# Final Version Dry Cask Storage Study

February 1989		_
U.S. Department of Energy Office of Civilian Radioactive Waste I Washington, DC 20585	Management	
	SAIC T & MSS RESOURCE CENTER	
	TESOURCE CENTER

The initial version of this report was issued in September 1988 for review and comment by State and local governments, utilities, other interested parties, and the public. It was also submitted to the NRC for review and comment. After comments were received, responses to the comments were prepared, and the report was revised as appropriate. The final report includes synopses of the comments and the DOE's responses; it also reproduces each of the comment letters in full.

Figure 3-6. Distribution by State of the maximum additional-storage requirements for the reference spent-fuel acceptance case.

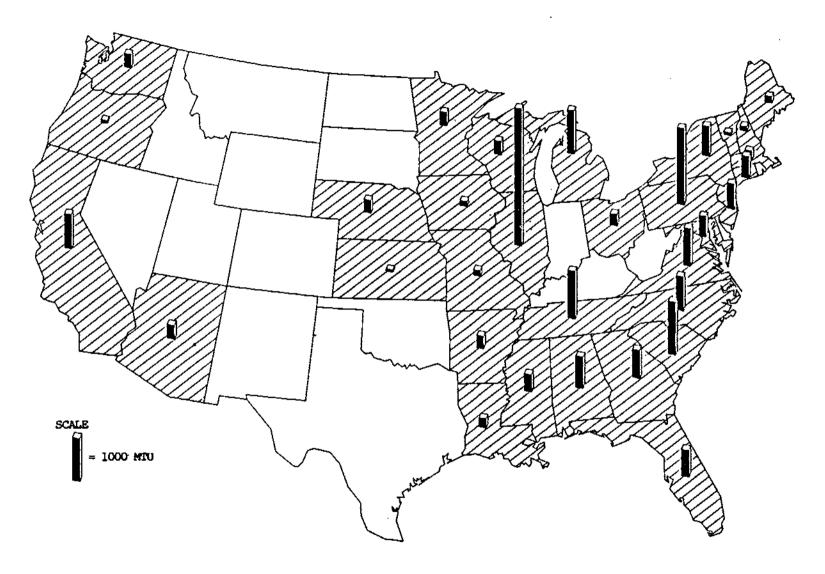
Page 24, Table 3-3 and Page 25, Figure 3-6:

Figure 4-5. Conceptual design for a modular vault storage system.

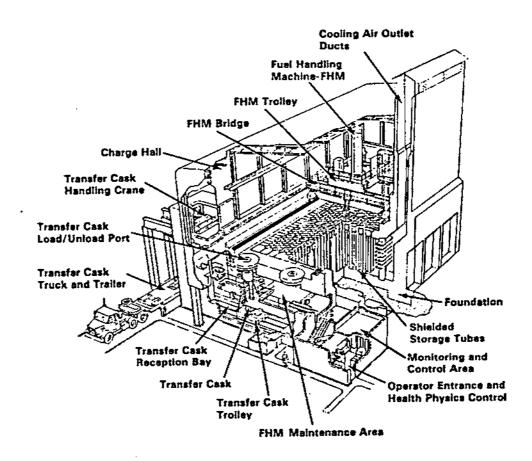
25	44	Figure 4.5	This figure can be cleaned up to remove the letters "FHM" wherever they appear and explain what "5 Off" means.
30-27 25	44	4.1.5.1/first paragraph, next to last sentence	Suggest adding the words "truck-type" between the words "standard" and "transportation casks".
20-21 27	45	4.1.5.4/last sentence	Ebasco's estimates indicate the upper bound should be considerably higher than 1.5 times the lower estimate.
28	46	4.2.2/first paragraph, first sentence	The words "without any spacer grids" make the sentence inapplicable to the Maine Yankee Consolidation License Application which assumed re-orienting the rods in a closer spaced simple grid array.
